**REF: Building Permit No. B18003546, 12538 Westland Court, Fulton, MD 20759
Permit Revision**

PERMIT PLAN WESTLAND FARM ESTATES LOT 7

Project: **WILLIAMSBURG GROUP**
WELLINGTON
WESTLAND FARM LOT 7

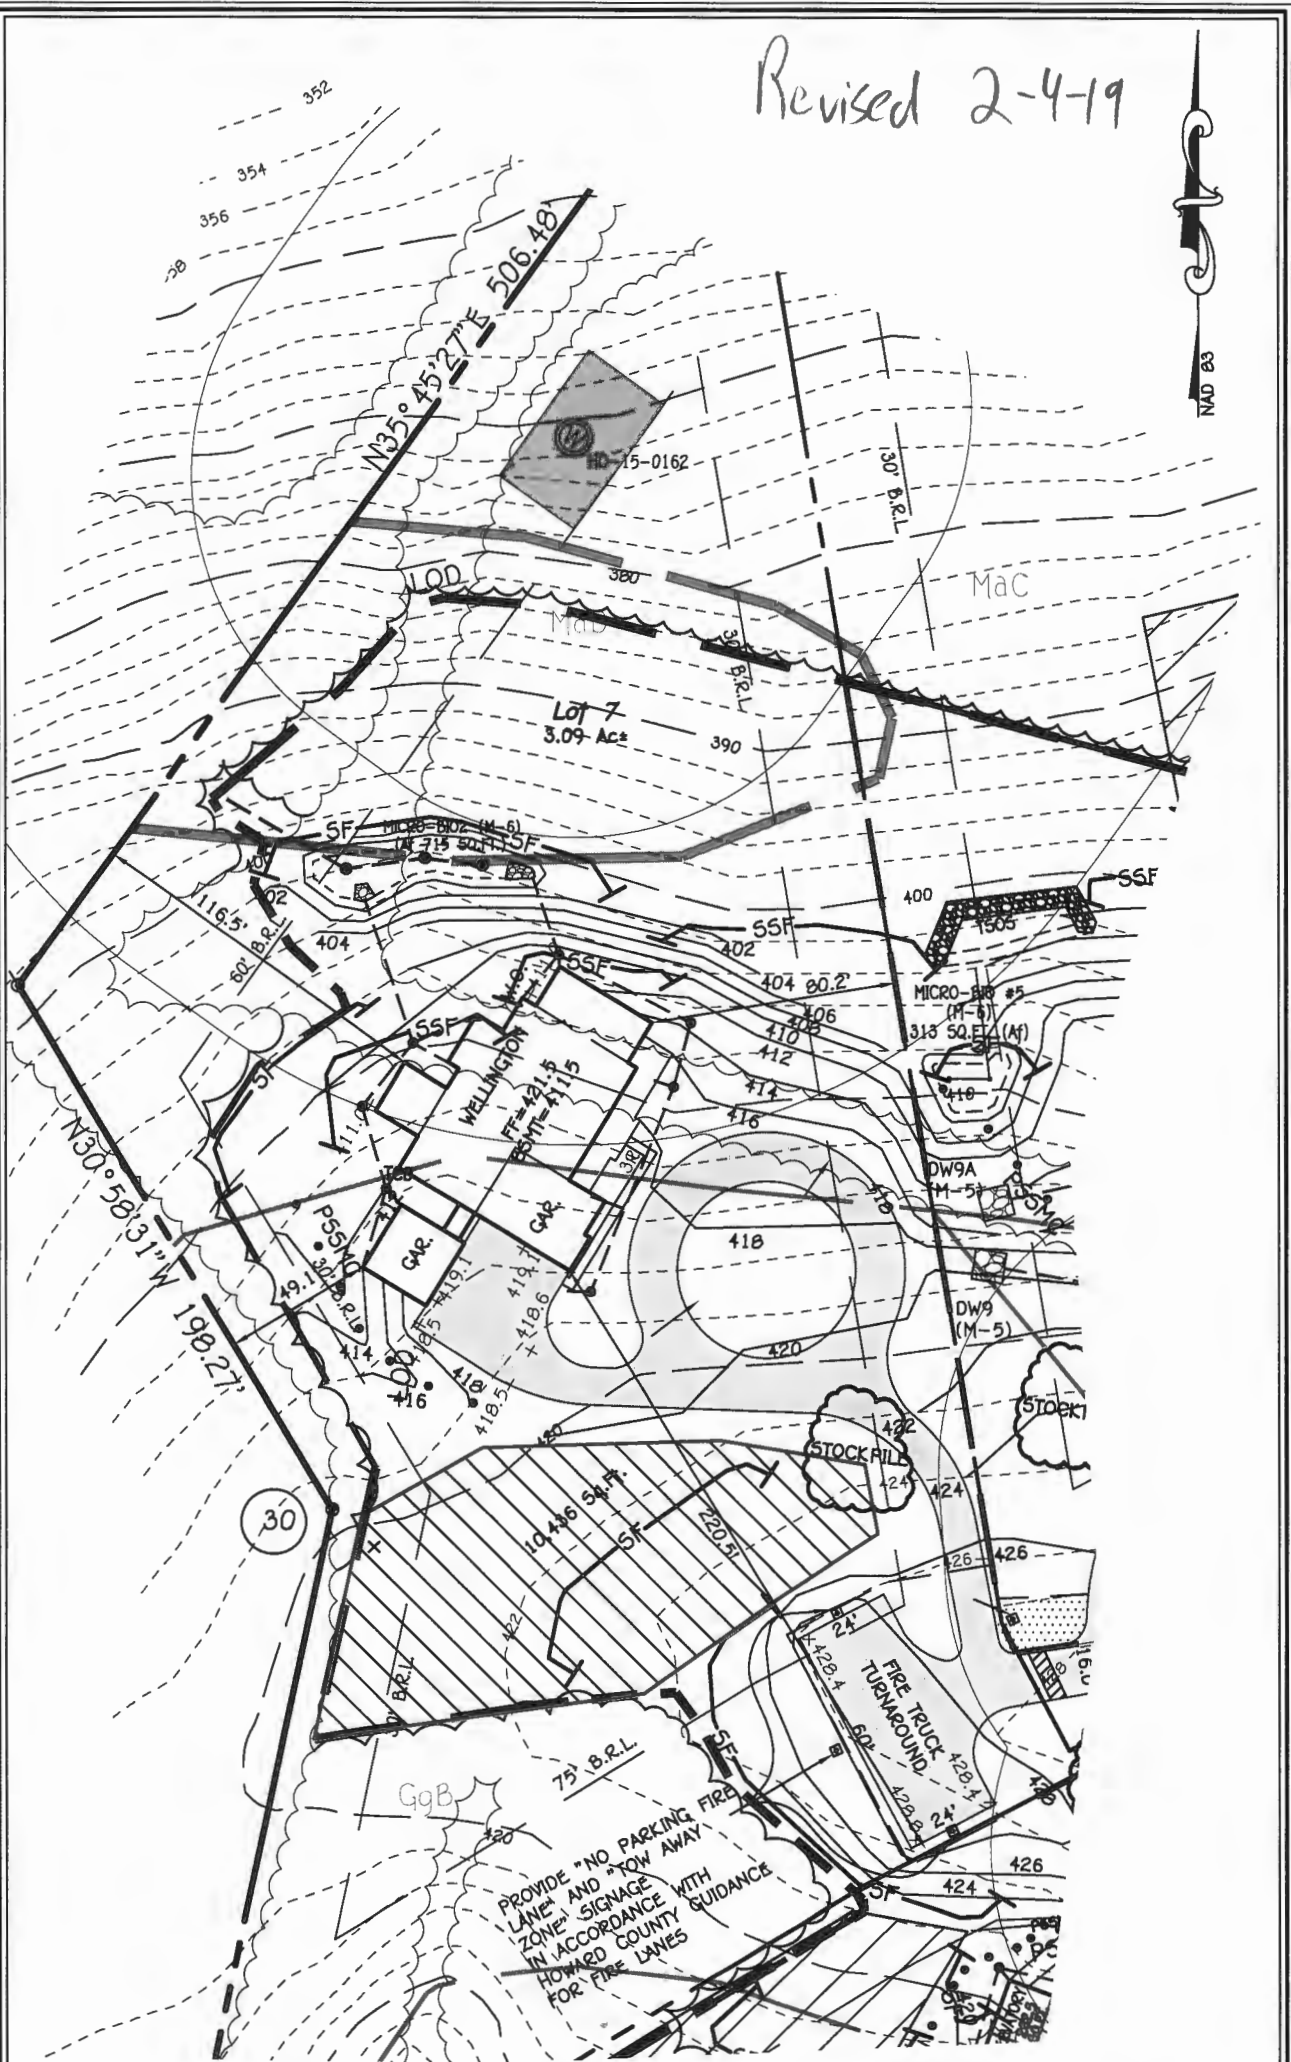
On November 9, 2018, I applied for this residential building permit for the construction of a "Wellington" house type on Westland Farm Estates Lot 7. Since then, we have changed it from garage right to garage left, we have added a circular driveway, we have pushed the house back, and we have adjusted the septic field. Attached is the new site plan to reflect all the changes.

Revised 2-4-19
